Access Compliance Report

Public Rights-of-Way

Intersection ID: 25995	Main Street: WEDDINGTON_RD	Cross Street: PLANTATION_CENTER_DR	Location: SW
ADA ID: 8FBB6D5884D7	Ramp Type: Para	Initial Pass/Fail: Fail	Overall Compliance: No
Codes/Mitigation Info/Possible Solution		Field Measurements/Component Compliance	
Severity Score: 26.25

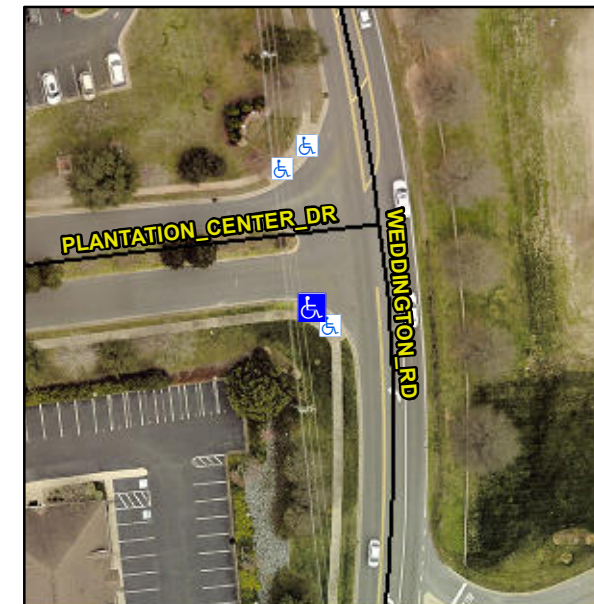
PROW/ADA:

R304.5.3, R304.3.2

Possible Solutions:

Remove & Replace Entire Ramp.
